SERVICE BULLETIN 29

SUBJECT: FITTING OF EARLY MODEL LANDING GEAR BOXES

APPLICATION: Glasair III aircraft; S/N 3003 thru 3008, 3013, 3015 thru 3017,
3021, 3022

FIGURE (1)

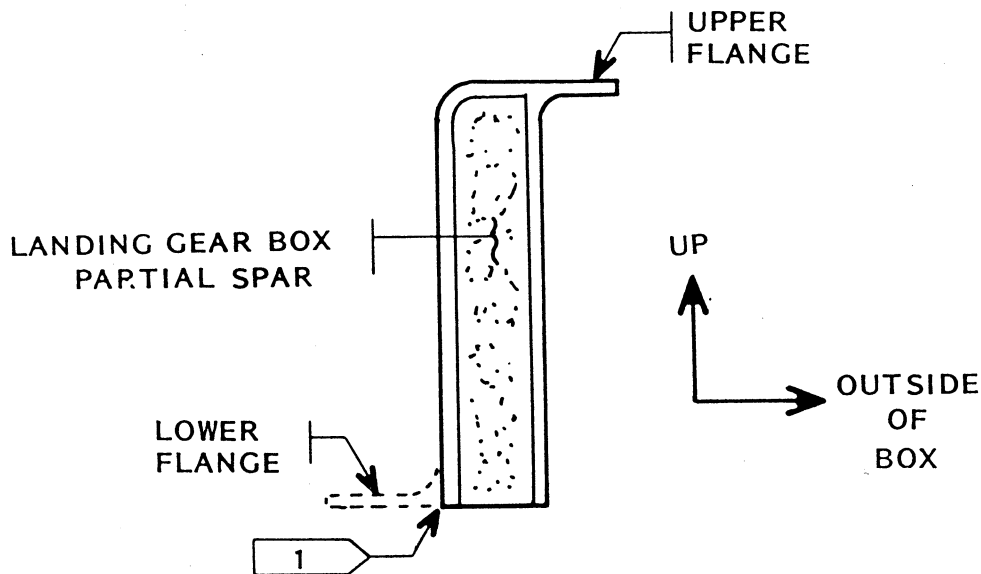
1. Cut off the lower flange of the landing gear box (the flange that is angled toward the inside of the box) flush with the side, as shown by Flag #1 in FIGURE (1).

FIGURE (2)

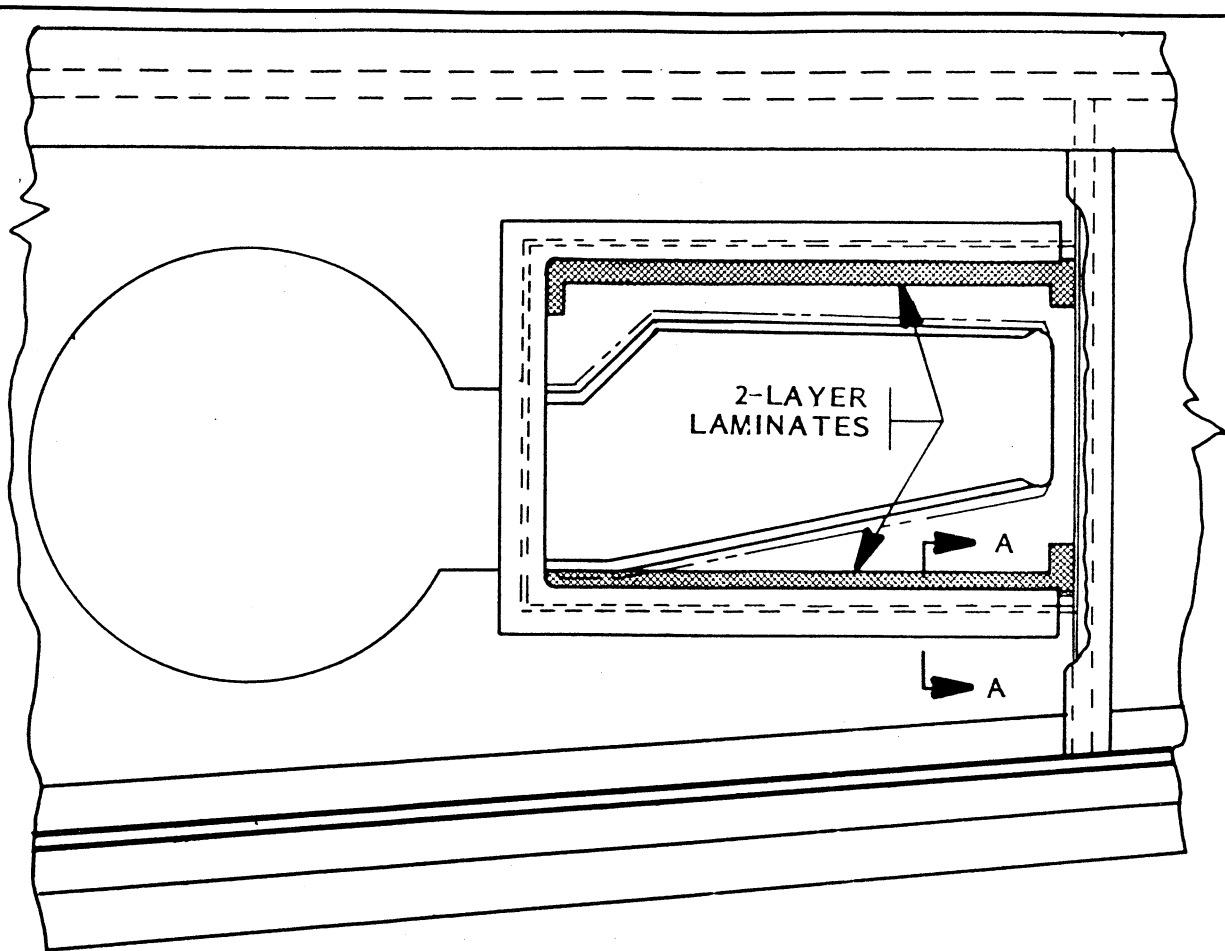
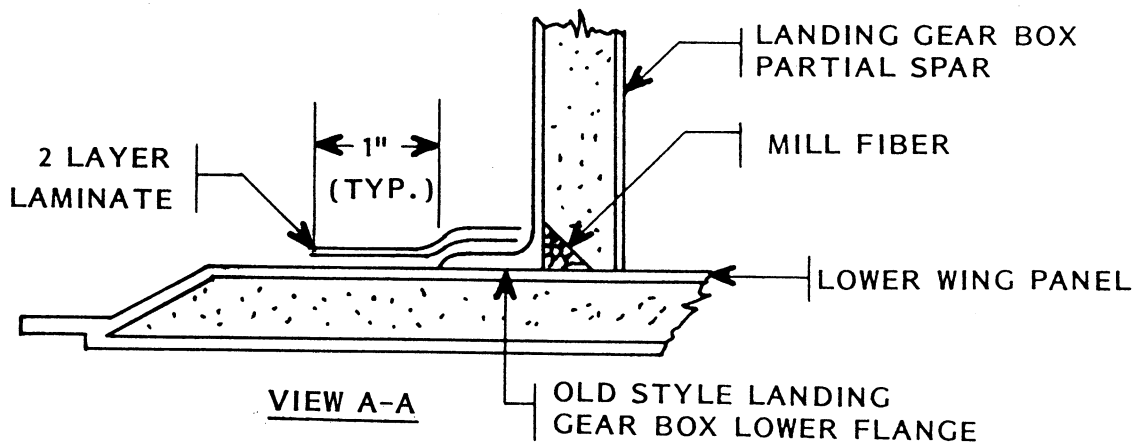
2. Apply the two layer laminates shown in FIGURE (2) of this Service Bulletin. The remainder of the installation of the old style landing gear box is the same as described in the Instruction Manuals with the following exceptions:

A. The (2) layer laminates attaching the lower wing panel to the landing gear box partial spars need only extend onto the lower flange, as shown in FIGURE (2), rather than continue all the way up the sides of the partial spar.

NOTE: The landing gear box lower flange will require trimming to clear the landing gear cutout in the lower wing panel. Where this occurs, wrap the laminates up onto the sides of the landing gear box.
